EDS545(53)

Widening of SR17/US 78 from SR 6 (Smith Mill Road) to South End of the Washington Bypass P.I. No. 222255

## Value Engineering Study Report

Concept Design Stage March 2005

DESCRIPTION: OPTIMIZE THE BRIDGE DESIGN

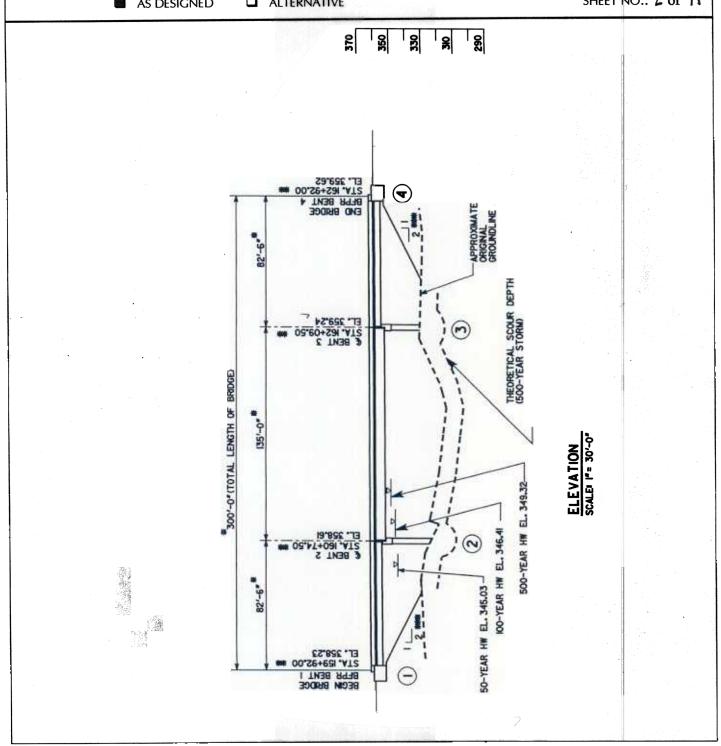
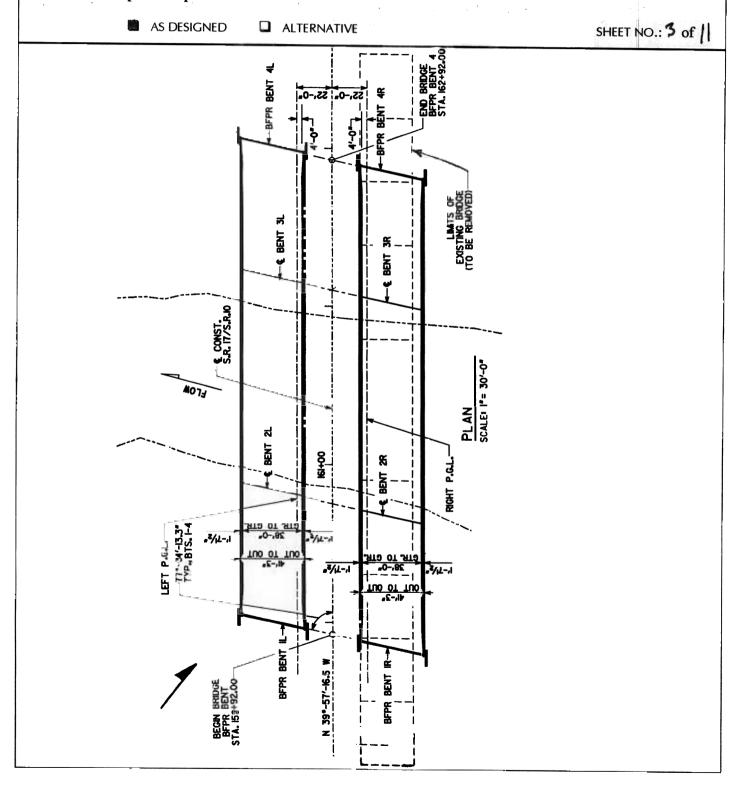
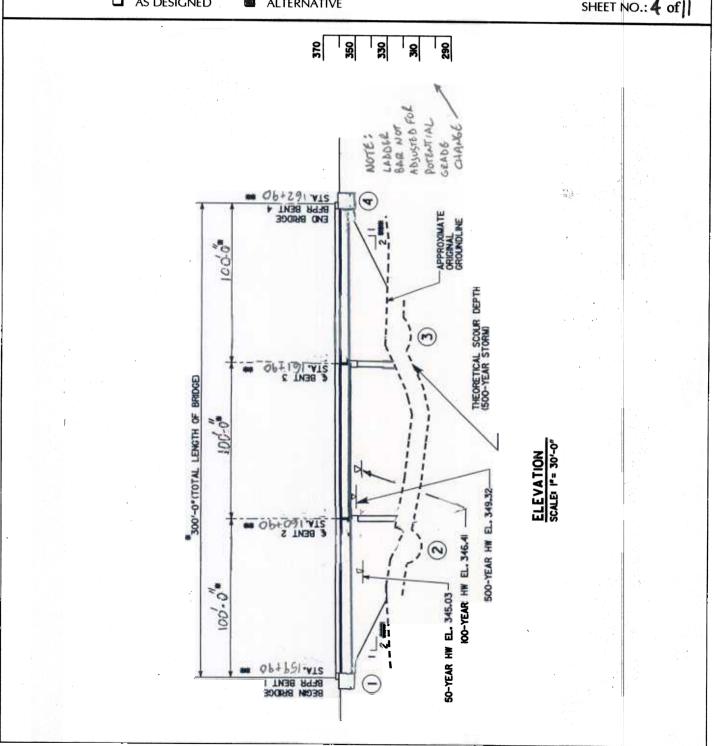
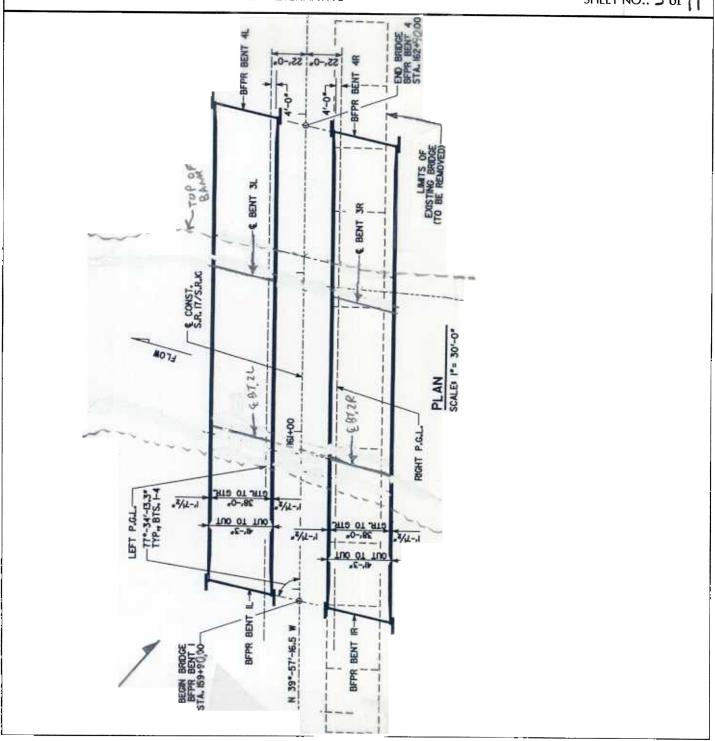
The original design spans the Little River with a solution using small end spans to establish the required hydraulic opening. The center span was based on 10-ft. setbacks from the top of the bank. It is noted that the top of the bank stations were incorrect.

This alternative acknowledges the river cannot be spanned with prestressed concrete beams which are commonly used for this type of river crossing. The alternative simplifies the current design by using only one beam type and making the spans the same lengths. This solution places bents in the river but places them away from the bank to reduce scouring.

Simplification of the new bridge over the Little River facilitates the construction effort associated with the bridge and takes advantage of using a single beam type to reduce the overall cost during bidding due to economy of scale. Although bents are required within the river, they would be placed away from the banks to minimize or eliminate the scouring effect of the water flow.

VE TEAM SPOKE WITH THE BRIDGE ENGINEER (SASTRY & ASSOC. \, THEY AGREE THAT THE VE TEAM TOP OF BANK STATIONS ARE CORFECT. THE VE TEAM ALSO SPOKE WITH SUSAN BECK (GOOT BRIDGE HYDRAULICS) MS BECK AGREES WITH THE VE TEAM TOP OR BANK STATIONS AS WELL. THE INTERMEDIATE BENT STATIONS MUST CHANGE, So,

THE 160.48' SPAN CREATED BY THE NEW TOP OF BANK STATIONS IS NOT ACHIEVABLE WITH 72" BULB TE

THE BENTS SHOULD NOT BE PLACED AT TOP OF BANK OR CLUSE TO THE BDGE OF STREAM. (THIS CONDITION INCREASES SCOUR AT THE BONTS).

WITH THE BRIDGE @ 300' LUNG: SUGGEST MAKE 3 EQUAL SPANS (100') AND COME IN EQUALLY INTO THE STREAM ON BUTH SIDES.

DESCRIPTION: ELIMINATE THE INTERSECTION NORTH OF THE

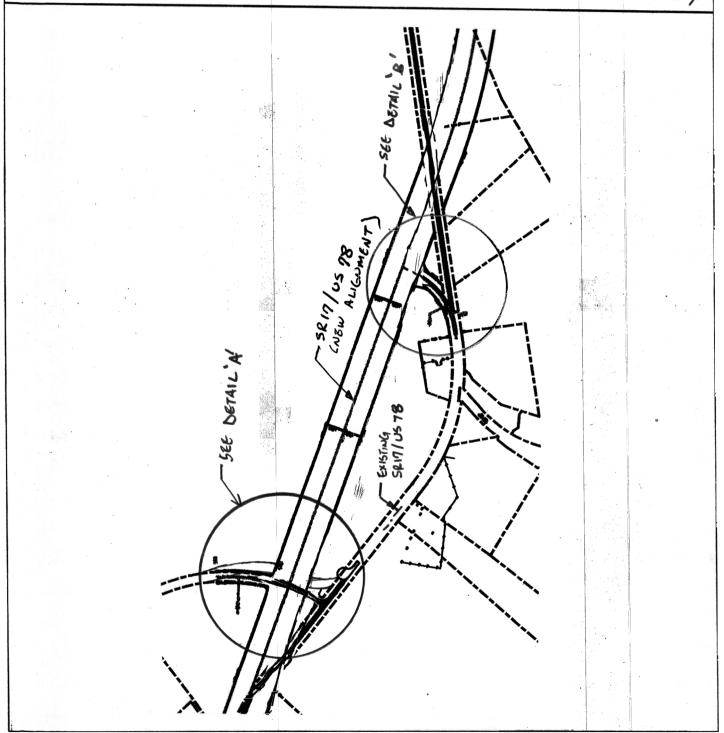
The original design creates a cul-de-sac of SR 17/US 78 on the northeast side of the Big Cedar Road Tintersection. A new T-intersection is created north of the Williams Leverett House approximately 2,700 ft. from Big Cedar Road. A third T-intersection is created 2,800 ft. further north along the proposed SR 17/US 78 new alignment with the existing SR 17/US 78 alignment.

Remove the intersection at Reynolds Road. Reynolds Road will have access to the new alignment via existing SR 17/US 78 and other proposed intersections.

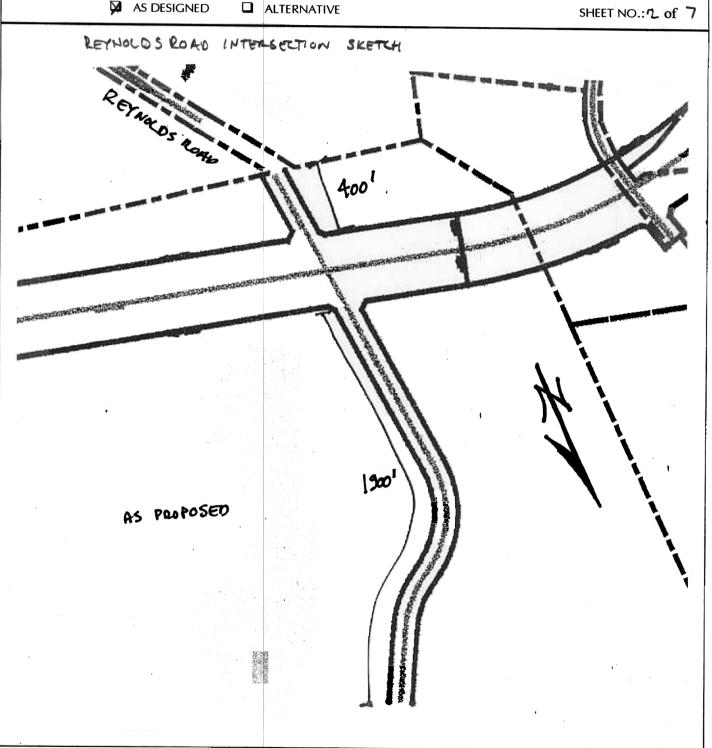
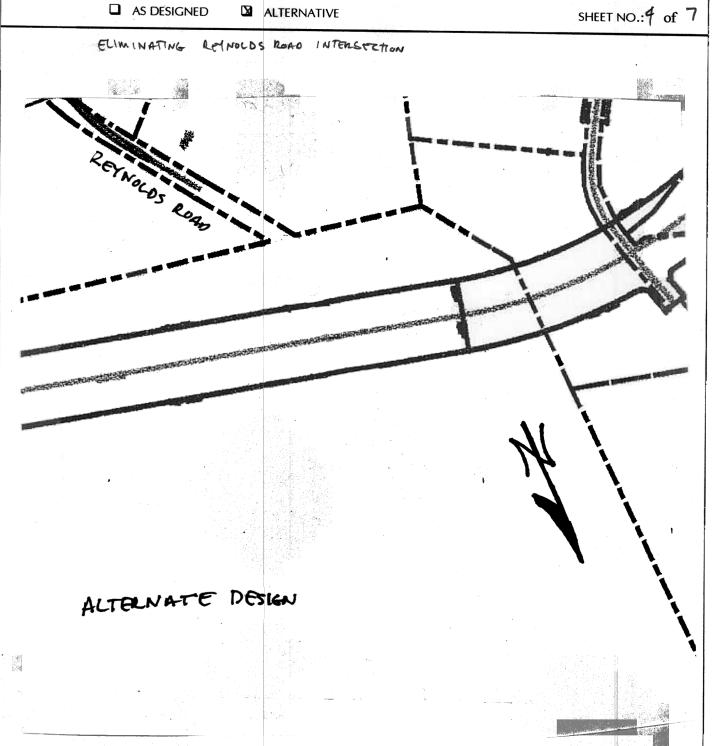
- Slightly reduces user convenience
- Reduces access points along the new location
- Limits development opportunities for undeveloped properties but could be added later

PROJECT: EDS-545(53), PI No. 222255 ALTERNATIVE NO .: WIDENING OF SR 17 / US 78 FROM SR 6 / SMITH MILL ROAD TO SOUTH END OF WASHINGTON BYPASS **McDuffie and Wilkes Counties** Concept Development ☐ AS DESIGNED ALTERNATIVE SHEET NO .: 3 of 1) PROPOSED TYPICAL SECTION FROM PROJECT-501 R/W

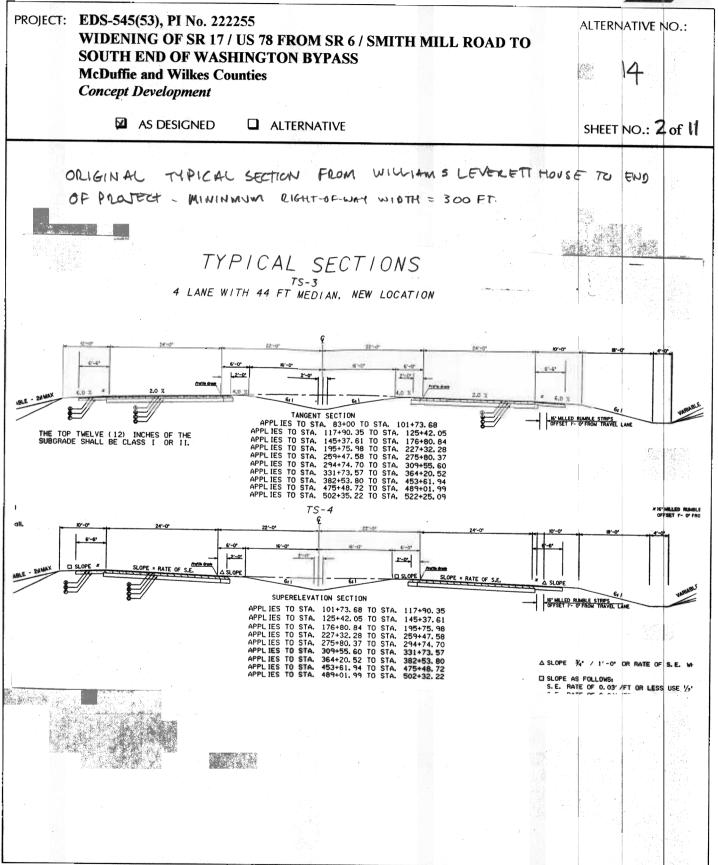
Retain the alignment on the existing location from the Williams Leverett House to the Washington Bypass but change the typical section to four lanes with a 20-ft. raised median and urban shoulder treatments with curb and gutter, sidewalks, and a closed drainage system. The minimum ROW through this section would be 100 feet wide which is the existing ROW width. Some additional ROW may be necessary for turning lanes.

- Creates a design speed not consistent with G.R.I.P.
- Requires lower speed limits with this type of section

Provide/develop a new western location for the widening of SR 17/US 78 using a portion of the existing alignment in lieu of the new eastern location.

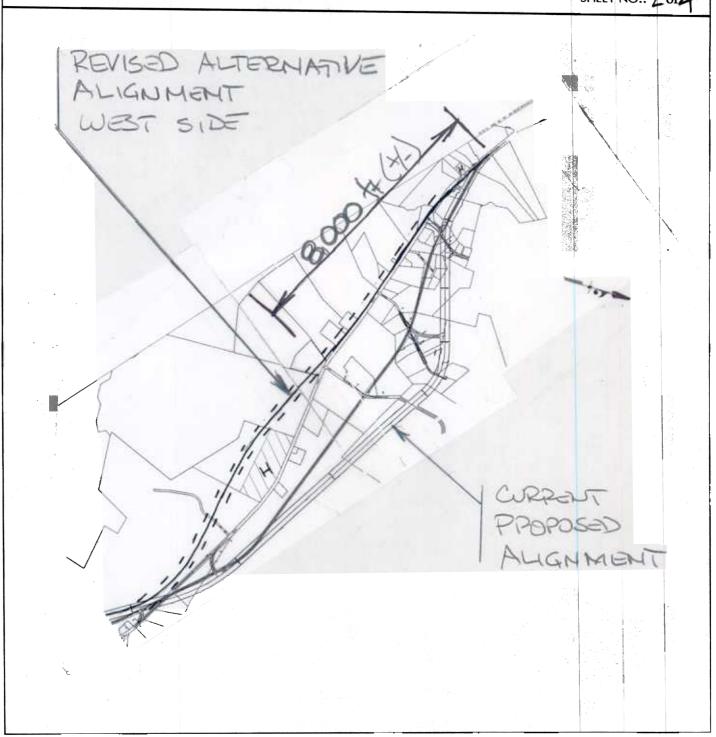
This alternative is possible if the current mapping's data is correct that only two historic properties exist on the west side: one small one in the vicinity of the project's northern terminus which can be easily circumvented and another larger parcel across from the Lincoln Bounds House in the vicinity of  $\pm$ STA 400. The larger parcel will require realignment to circumvent. However, for a significant portion of the alignment (about 8,000 ft.) this alternative can parallel the existing roadway and alignment. This will permit a reduction in the required right-of-way, eliminating some displacements and potentially using some of the existing roadway. This could contribute major cost savings to the project.
